<div>ABBOTT ADD</div>	<div>INDEX</div> <div>INSTRUMENT SERVICE ADVISORY</div>
--	---

PRODUCT: LCx® Probe System (69)	DATE: 07-JUL-98
---	---------------------------

ABBOTT
ADD

SUBJECT: LCx® Service Manual	ISA#: 69-013
ORIGINATOR: Eric Tormos	PRODUCT: LCx® Probe System (69)
APPROVED: Jack B. Hall 7/7/98	EFFECTIVITY DATE: 07-JUL-98

Figure ISA 69-005-1:
Manual Amplification Vial Retainer (top view)

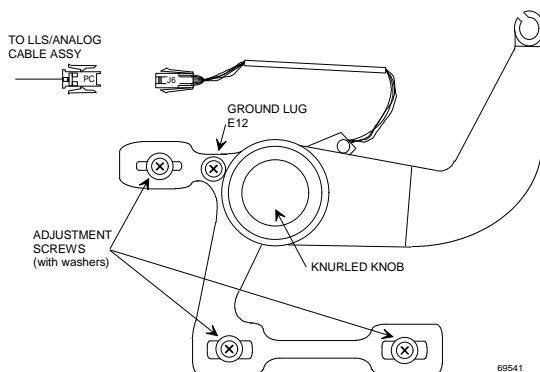
In addition, the use of the manual Amplification Vial Retainer (AVR) affects several removal/replacement procedures. These revised procedures are provided in this ISA:

The locked/unlocked status is sensed by the AVR Home Sensor. The system software checks the lock sensor before and during an assay. Verify functionality of the AVR Home Sensor by using the Dispense Hand Controls.

The AVR is connected to the Analog Board via the LLS/Analog Cable Assembly.

The AVR is compatible only with Boom Assembly CN 3-47090-02. This boom assembly does not have an integrated AVR.

Figure ISA 69-005-6: Manual Amplification Vial Retainer

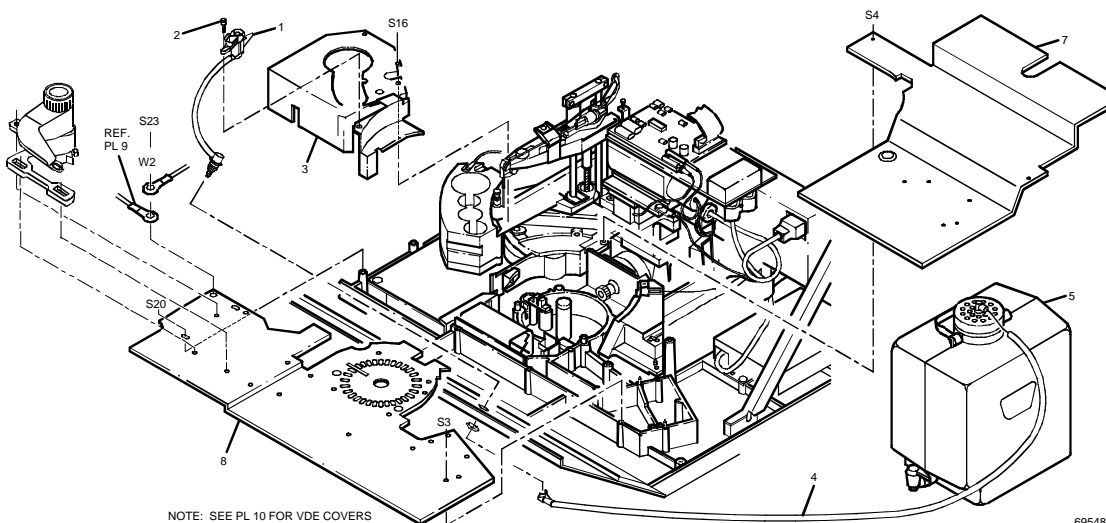
1. Remove the Enclosure Assembly (RR 1.3).
2. Raise the Display (RR 8.1.1).
3. Remove the left VDE Cover (PL 10.2).
4. Detach the Wash Station from the Reagent Shroud.
5. Remove the Reagent Shroud (RR 2.3).
6. Remove screw from AVR ground terminal lug E12.
7. Detach cable connector J6 (from the AVR) from LLS/Analog Cable Assembly cable connector PC.
8. Remove the AVR from the Air Duct Cover Assembly (3 screws and washers).

Perform the following procedures in the order listed:

1. Reagent Heater Block Adjustment (VP-21)
2. Boom Calibration (VP-8)
3. Level Sense Check (VP-11)
4. AVR Alignment (VP-64, procedure provided in this ISA)
5. AVR Sensor Check (VP-65, procedure provided in this ISA)
6. Buffer Sensor Check (VP-15)
7. Total Service Call Procedure

Figure ISA 69-005-13: AVR Positioning Tool

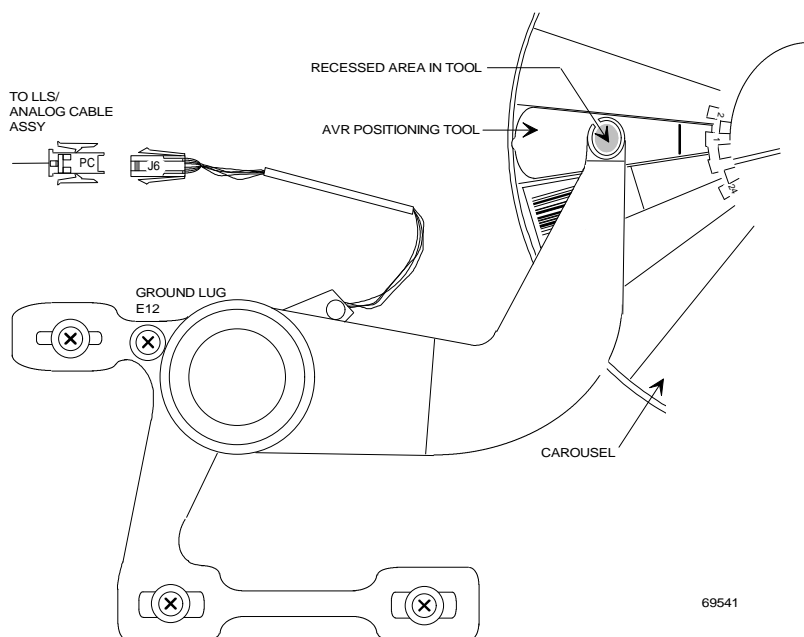
Purpose: To align the AVR over the carousel and vial.

1. Place the AVR Positioning Tool in carousel position 1 of the LCx® carousel. Lock carousel and place carousel into the analyzer.
2. Lock the AVR (turn the knob counterclockwise).
3. From the Main Menu, press:
 - MONITOR
 - HND_CTRL
 - OTHER
 - OTHER
 - LS
 - OTHER
 - OTHER
 - CR_POS1
4. Visually align the oval opening at the end of the AVR arm over the oval indentation in the AVR Positioning Tool.
5. Tighten the 3 (three) screws securing the AVR to the Air Duct Cover Assembly.
6. Press CR_POS1. Verify that the alignment has not changed. (If necessary, loosen the three screws and repeat the alignment.)
